**Re: Docket 4237  
Commission Investigation Relating to Stray and Contact Voltage Occurring in  
Narragansett Electric Company Territories**

**Re: Docket 4237  
Commission Investigation Relating to Stray and Contact Voltage Occurring in  
Narragansett Electric Company Territories**

Premier Utility Services respectfully submits comments to the Rhode Island Public Service Commission on the document titled "Factors Influencing Con Edison's Current Position on the NARDA 8950 System". This document was included as an attachment to a previously filed submission by Mr. & Mrs. Green, and referenced in a submission from Power Survey Company.

**Slide 6 and Slide 7**

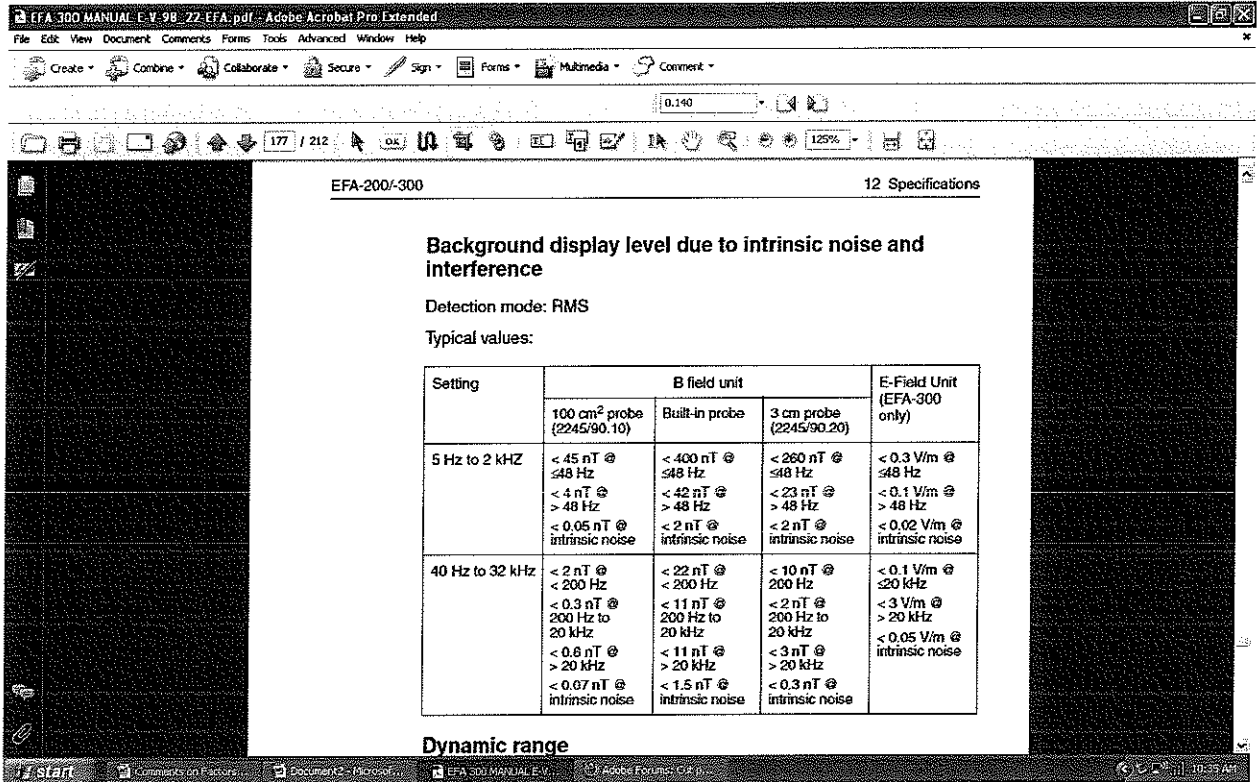
- NARDA EFA-300 sensor has a published floor noise of 0.140 V/m when the sensor is static
- NARDA 8950 System has noise floor, when moving, of approximately 2V/m based on charts from NARDA

are incorrect. In the NARDA EFA 200/300 EM Field Analyzer Operating Manual (BN 2245/98.22), page 12.13, the *official* NARDA Corporate published specification, for 60Hz signal detection, is <0.1 V/m at 60Hz and <0.02 V/m at intrinsic (static) noise. The NARDA 0.140 V/m number was simply a value selected for that particular paper for reasons unknown to Premier.

Too, data retrieved from the NARDA systems software logging function shows that the 0.070 V/m level, and by extrapolation the 0.140V/m level, is routinely surpassed by the 8950/10. A small selection of data retrieved from one recent mobile survey:

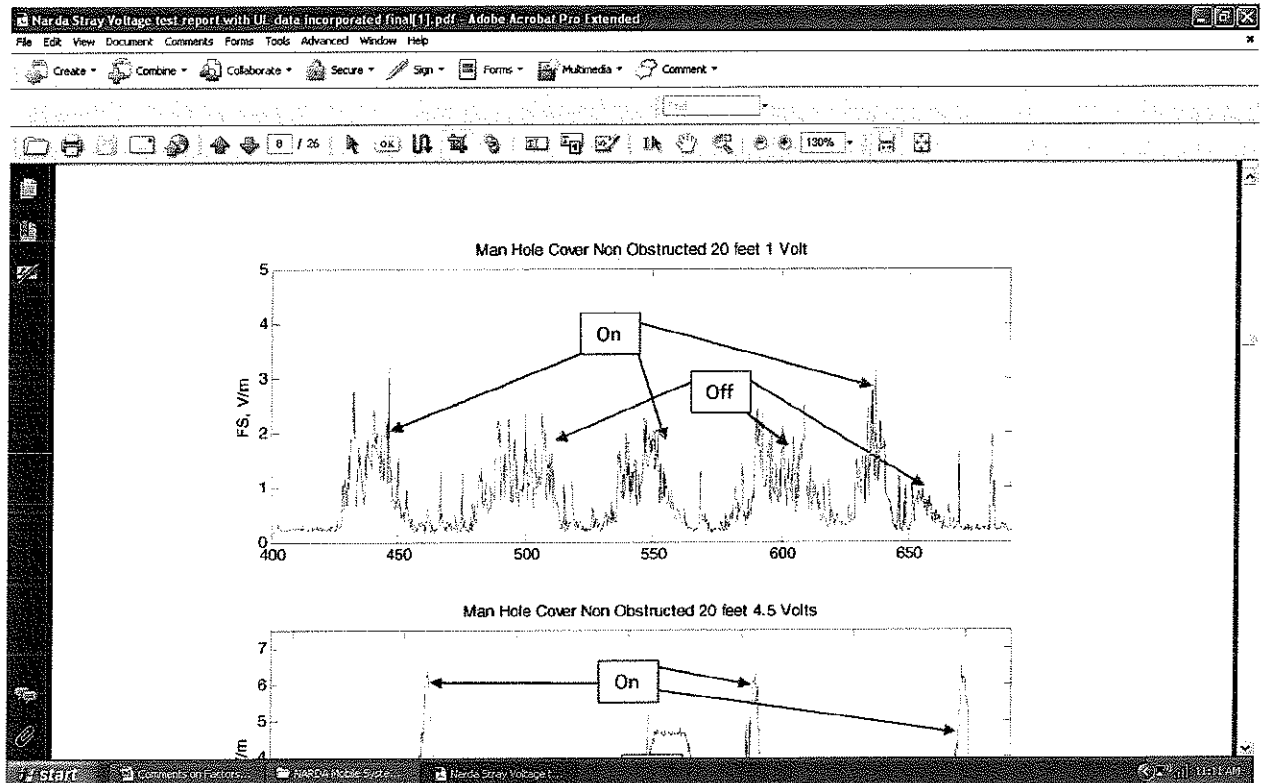
The associated Slide 7 shows a line called the “Moving Noise Floor”. This was something added by the ConEd author(s) based upon their opinion as to what that level should be. As the image actually appears in NARDA documents:

This chart represents 300 data points (400-700). At no point in the document does NARDA mention this concept termed “Moving Noise Floor”.

### Slide 8

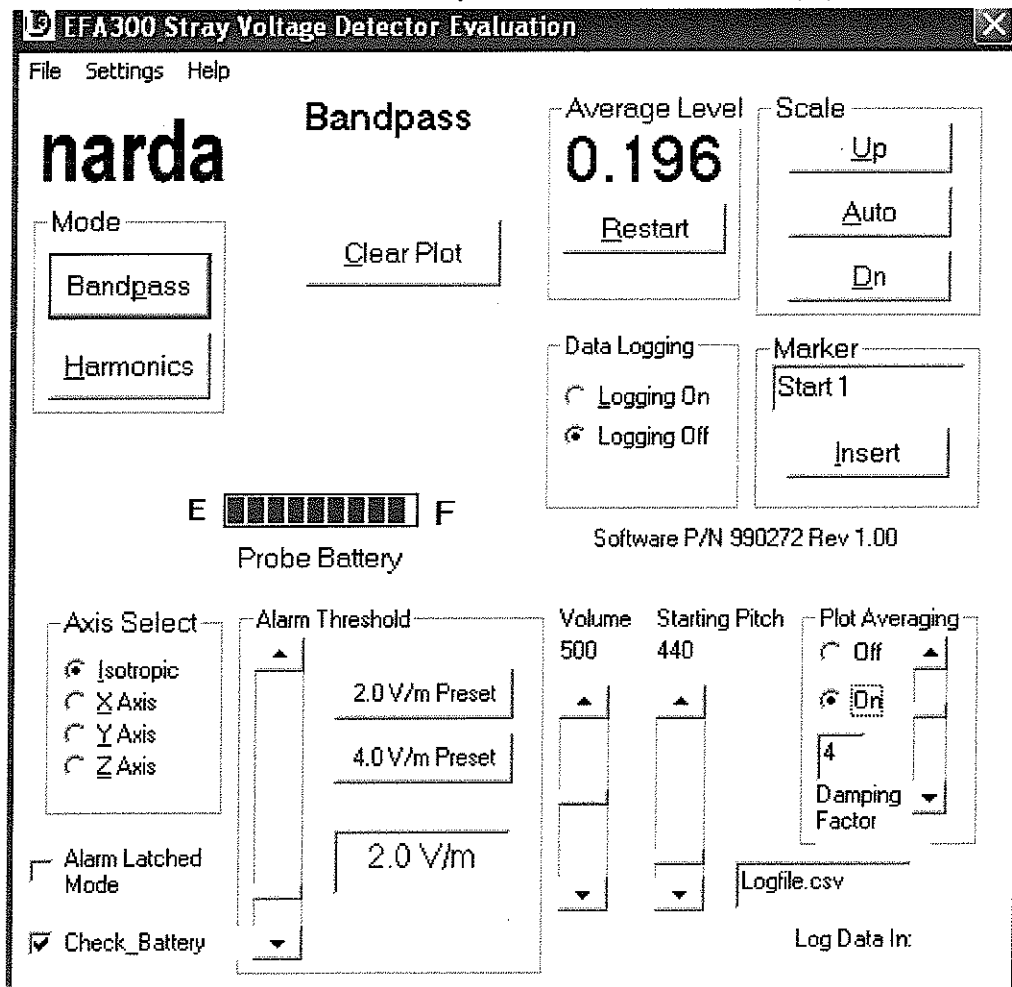
- **NARDA sensor is sensitive to vibration from bumps and potholes on the road.** While not observed in Premiers operation of the NARDA 8950/10, ConEd may have experienced a problem called *microphonics*. This is a very simple problem to fix and is well described in the literature. Somewhere, ConEd had a loose mechanical connection, probably in the boom attachment on the back of the truck.
- **EPRI handheld sensor shows similar response to bumps and potholes.** This is irrelevant to the discussion of the NARDA system as the EPRI unit is not intended to be used as a mobile survey system.
- **SVD filters or dampens these events.** This is simply because the SVD has a different signal sampling rate than the NARDA 8950/10. The NARDA samples 12 times a second, and displays an

average of those readings on screen once every second. Too, any “blip” that may be associated with vibration/road bump will display as an instantaneous spike, where as true electric fields detected display on the screen with a certain distinctive run/rise pattern.

- **To avoid false positives from these events the user may opt to increase the detection threshold, reducing the number of detections.** This is fundamentally incorrect, and shows that ConEd did not fully understand how the system or software operates. The detection threshold on the NARDA 8950/10 is not adjustable. They are confusing the detection level with an alarm setting, which is adjustable. This is a screenshot of the NARDA software expanded Settings window. There is no detection level adjustment available on this equipment:

As you can see, the Alarm Threshold is set for 2.0 V/m, but in the Averaging Level display the system is still detecting 0.196 V/m in the upper right hand corner. **The Alarm setting does not control the detection level.**

# Data from Power Survey

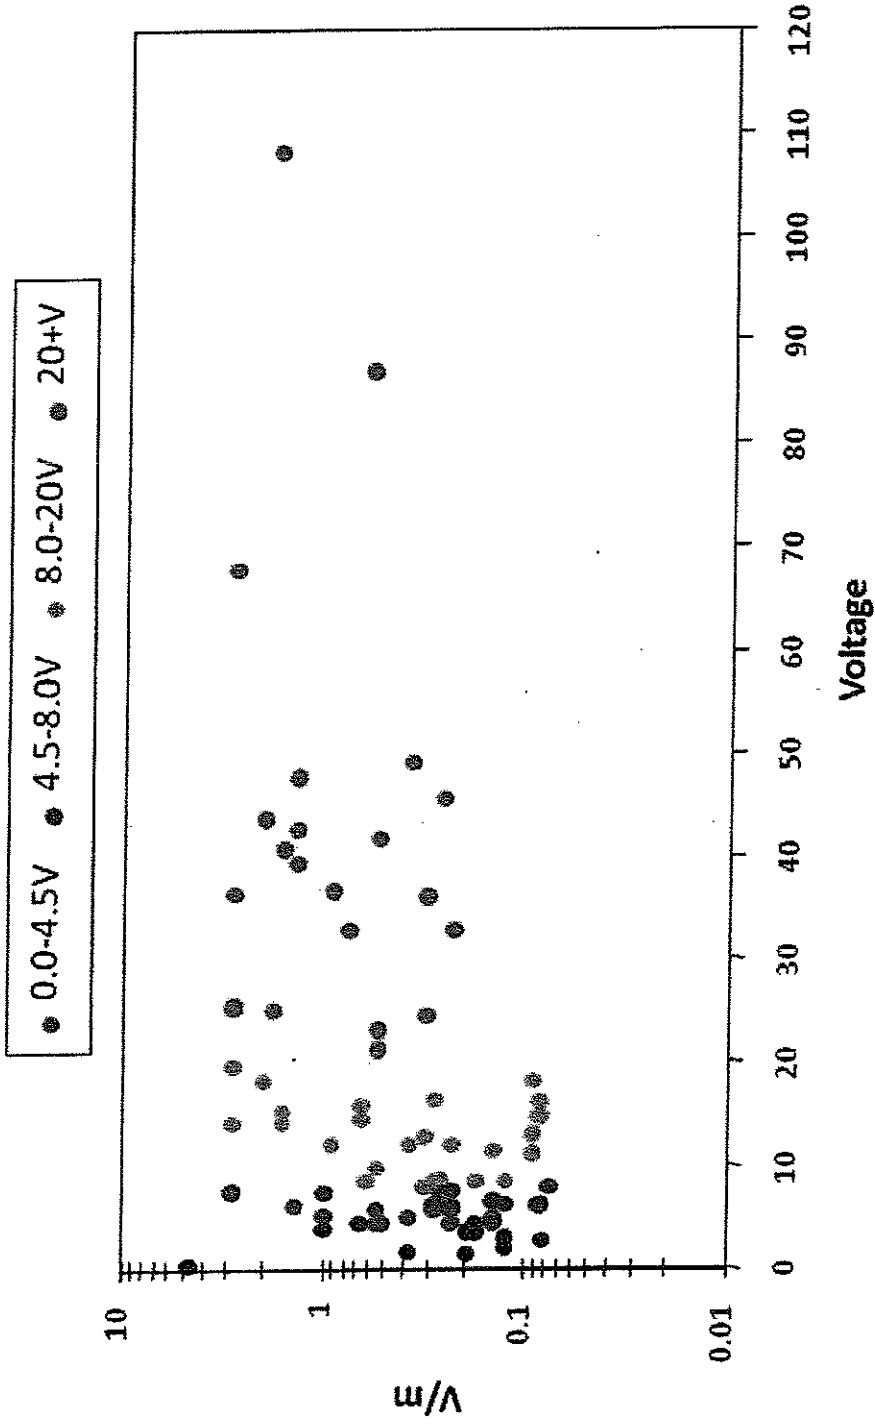
**Slide 11.** We cannot comment on the actual data set supplied by Power Survey, and believe that is correct, but again, the error here is that ConEd is confusing the NARDA System alarm function setting of 2.0 V/m as the detection level. So, yes, using that incorrect number on this chart **would** show that the NARDA misses most objects. But, we have presented here that the NARDA does detect electric field strength of less than 0.1 V/m, so it would pick up every object on this chart. Why did ConEd miss 4 or the 6 objects? They were focusing solely on listening for an alarm rather than looking at what the screen was actually telling them.

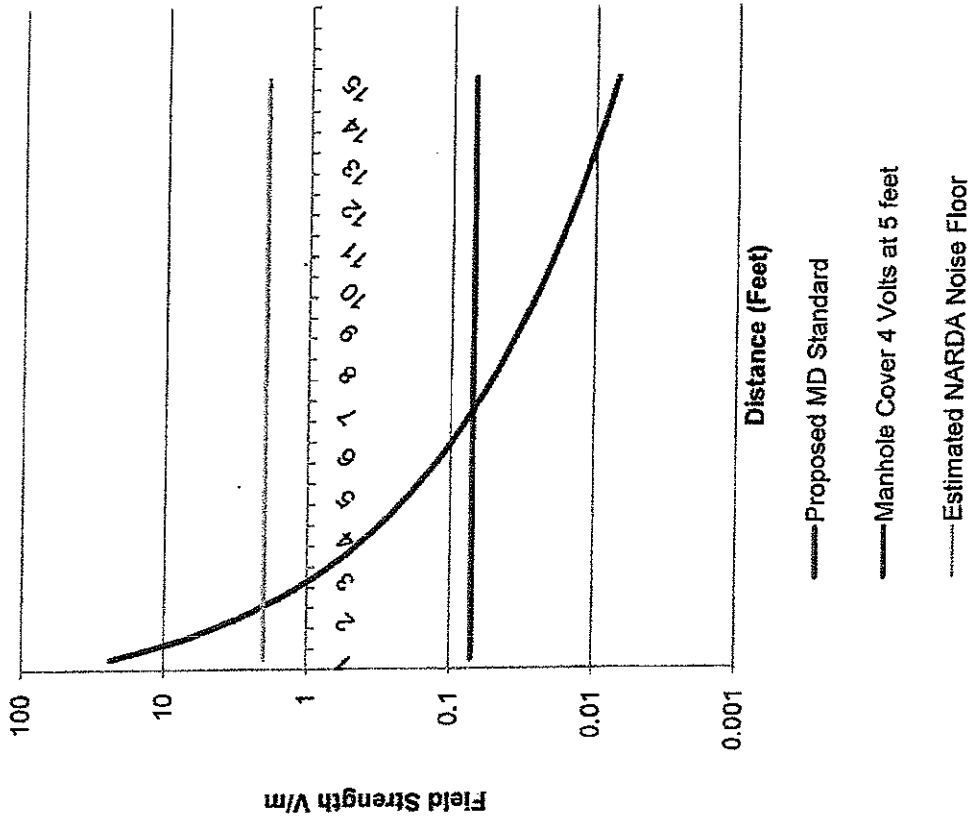
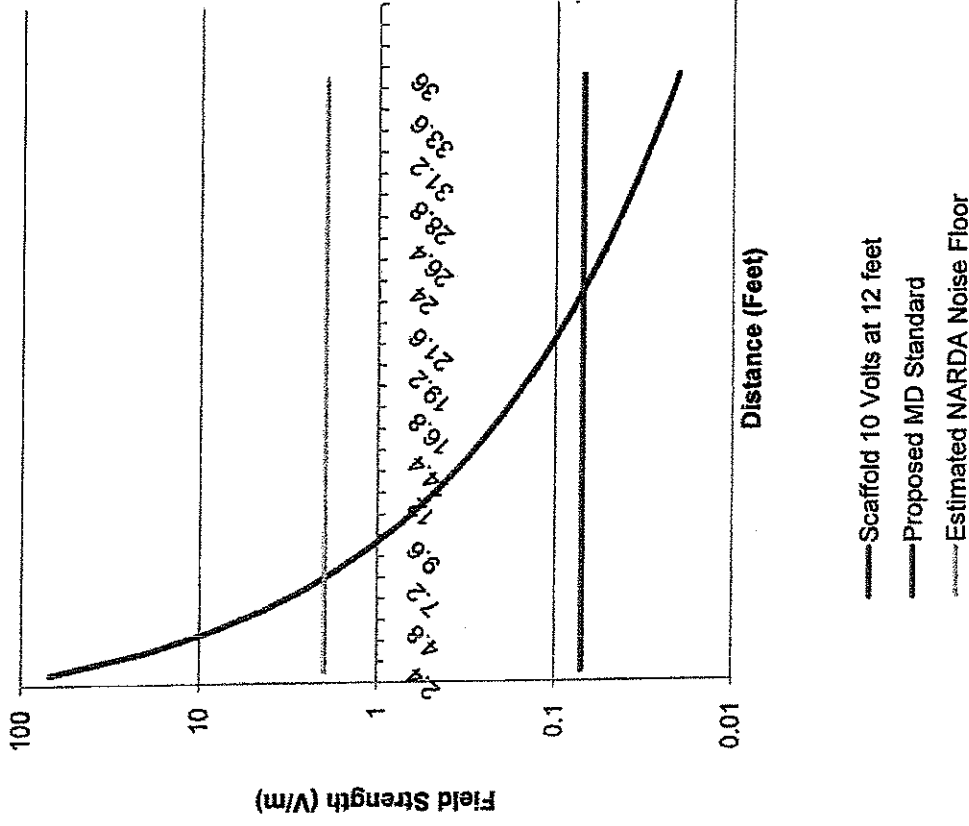
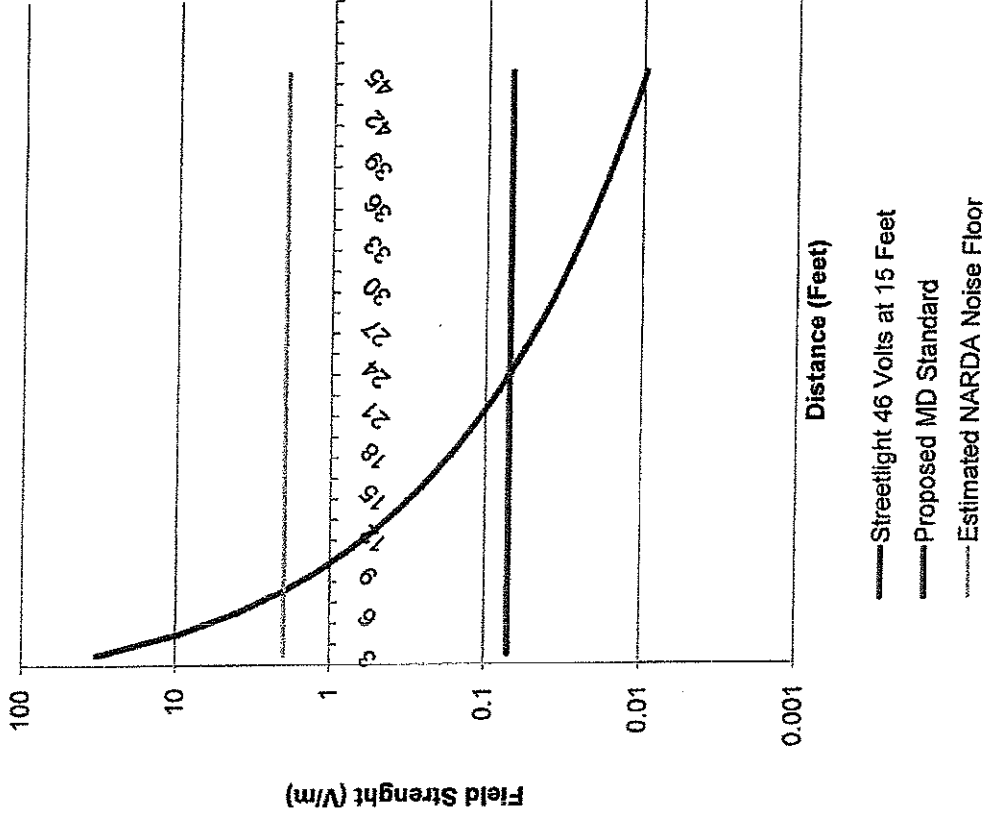
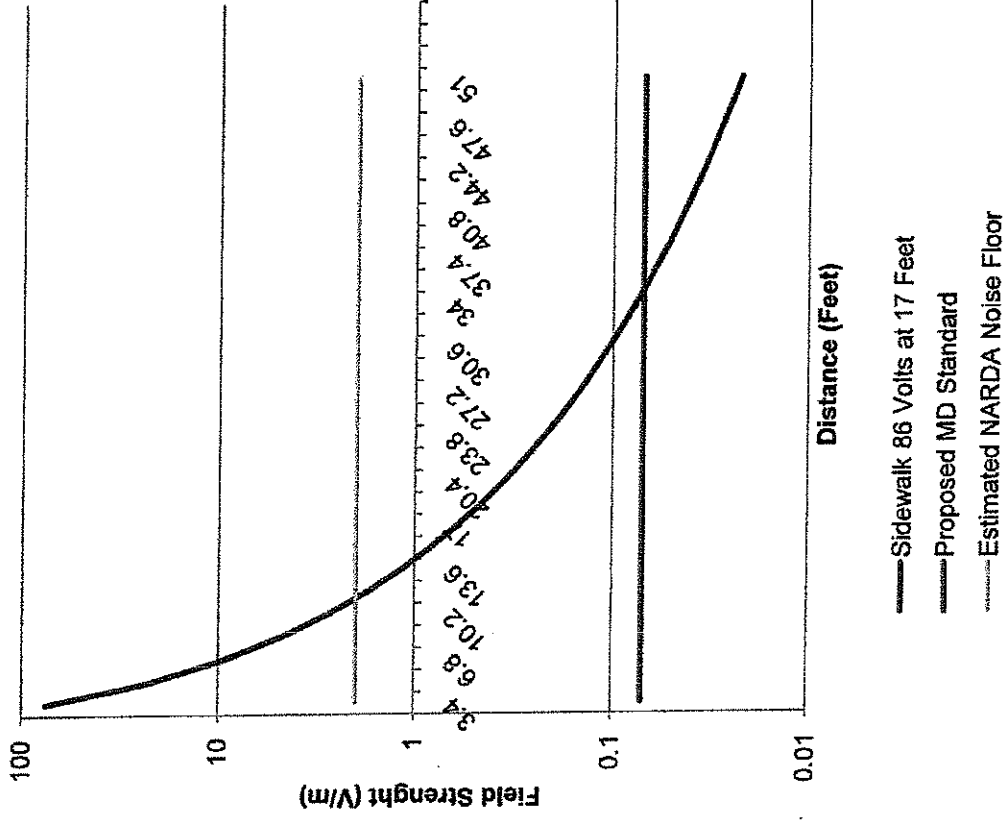
**Slides 14-18** again, incorrect based on a wrong software assumption.
